Ref: 44-02-115-C Swing Bridge Deck Repairs 2023

This Addendum #2 contains (6) pages including this front page.

ST GEORGE'S
SHEET TITLE:
DECK REMEDIATION
TYPICAL SECTIONS

Photograph 1 – Bolt clarification

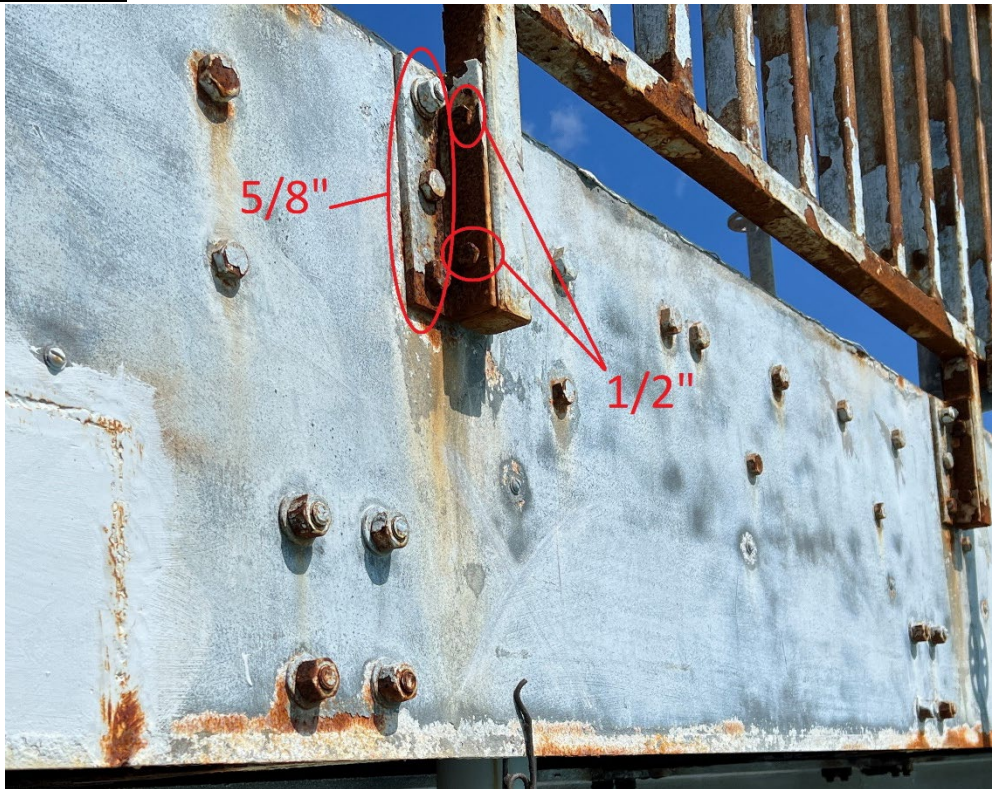
1. Q) Please advise the size of the bolts that hold the handrail to the decking edge plate as their not shown or called out in the drawings. These will probably have to be replaced with new as we think that many will have to be cut off, so we want to allow for a certain percentage of replacement bolts.

A) After receiving this question we measured the bolts on site and checked the record drawings. The handrail bolts are two different sizes. Bolts connecting the angle bracket to the handrail are 1/2", while the bolts connecting the angle bracket to the decking edge plate are 5/8". The relevant drawing S301 has been updated to reflect this information, and a photograph is included for additional clarity.
